CENPD-300-NP-A

# Reference Safety Report for Boiling Water Reactor Reload Fuel

UNITED STATES  
NUCLEAR REGULATORY COMMISSION

SUBJECT: CENPD-300-P "REFERENCE SAFETY REPORT FOR BOILING WATER REACTOR  
RELOAD FUEL," (TAC NO. M91197)

Figure F9-1 Typical Core Power Transient Response for Generator Load Rejection and Loss of Feedwater Heating Events

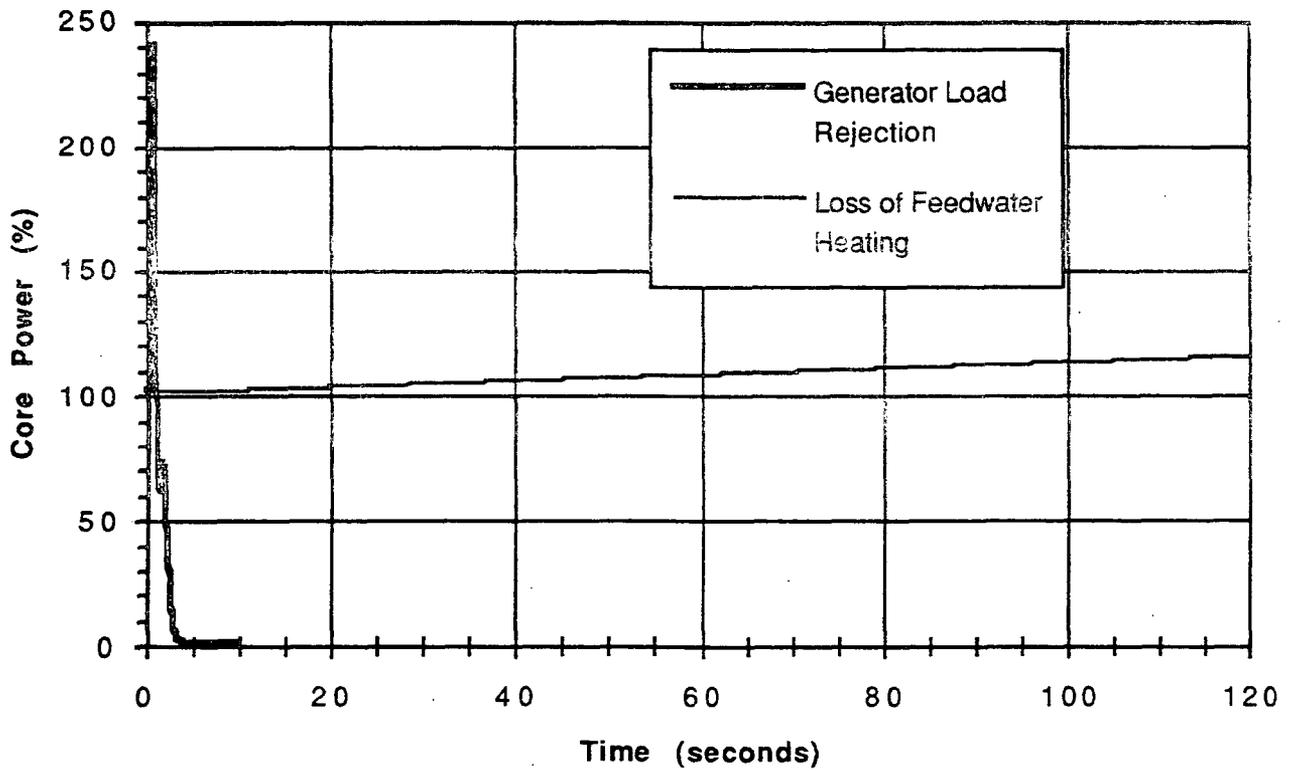
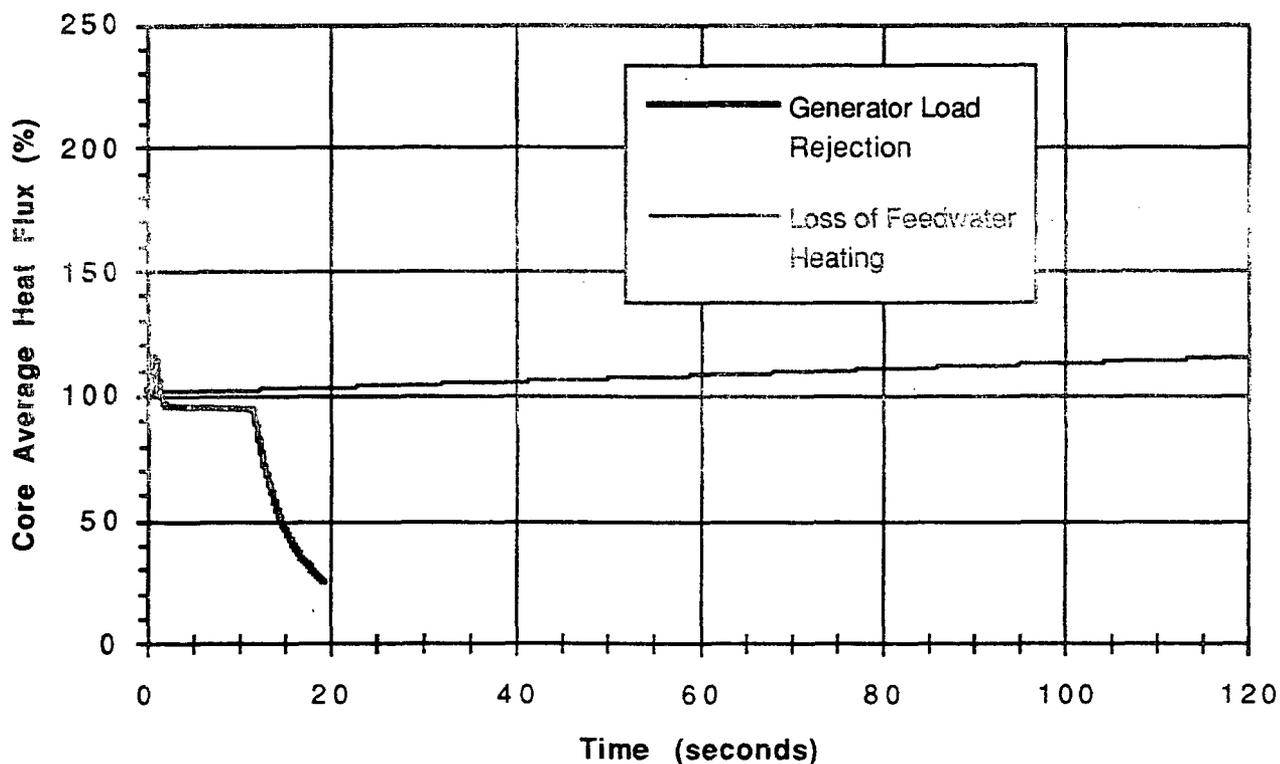
Slow transients are generally characterized by relatively slow changes in neutron flux (events with a time scales of several minutes, such as, changes in moderator temperature). In these events the reactor heat flux closely tracks the neutron flux. Protective action for these events, if required, is based on neutron flux or simulated thermal power. For slow transients, the simulation of the system response is relatively unimportant, but the simulation of the three dimensional core response (i.e., changes in power distribution) is important. In illustration, Figures F9-1 and F9-2 show the core power and heat flux
